**AMENDMENTS TO THE DRAWINGS**

**REMARKS**

FIG.5C

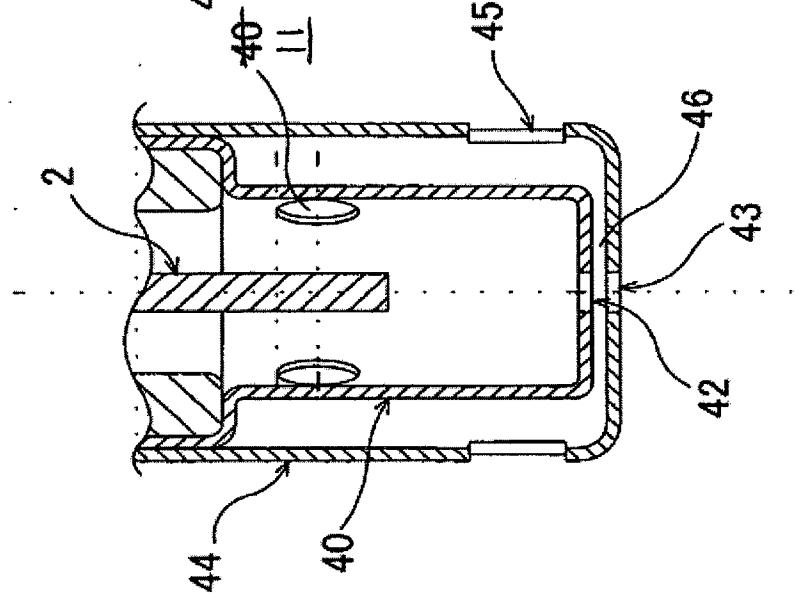
In response to the drawing objections, reference numeral “40” at the right-hand side of Fig. 5(C) has been changed to “11” to designate inner-wall gas inlet openings. Reference numeral “26” has been removed from Fig. 6.

In response to the drawing objections, reference numeral “40” at the right-hand side of Fig. 5(C) has been changed to “11” to designate inner-wall gas inlet openings. Reference numeral “26” has been removed from Fig. 6. Reference numeral “44” is described in paragraph [0086] at page 38 of the specification, and refers to the outer hollow-cylindrical portion 44 of the second comparative Example Fig. 5C. Replacement drawing sheets are submitted herewith. Withdrawal of the drawing objections is respectfully requested.
